Accelerated Corrosion of Copper-Nickel Piping

NMAB-343

**THE COMMITTEE ON ACCELERATED CORROSION OF
COPPER-NICKEL PIPING**

**Publication NMAB-343
National Academy of Sciences
Washington D.C.
1977**

FIGURE 1 Typical Appearance of Corroded Inside Surface of Cupro-Nickel Piping. (Courtesy of U.S. Naval Ship Research and Development Center.)

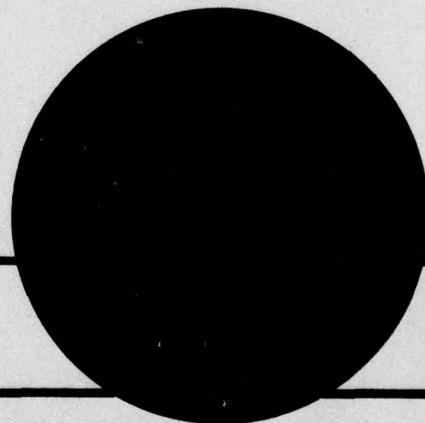
Analysis of the corrosion problem was conducted over a period of some three years at the David W. Taylor Naval Ship Research and Development Center. Figure 1 is a photograph of the inside of a corroded pipe. The phenomenology of the deterioration is as follows:

1. The majority of the damage occurred downstream from M bronze fittings and elbows (containing around 6% Sn, 1.5% Pb, 4% Zn, 0.5% Ni, balance essentially copper). These fittings caused turbulent flow at the pitted locations. There were occasional examples of erosion or localized attack as far as 2 to 3 feet from the elbows and flanges. These occurrences were limited. Pitting rarely occurred upstream of elbows or flanges.

2. The appearance of the corrosion product film in the pitted region was quite different from the normal dark brown adherent cuprous oxide coating that forms on CDA*706 (90/10 copper-nickel) in clean seawater. Instead, the films in the sites of localized attack were black or brown and were accompanied by flaky films that exhibited green, black or sometimes red colors.

3. Corroded areas generally were deep and sharply scalloped and exhibited symmetrical features. Erosion of the downstream edges of the pits was sometimes observed.
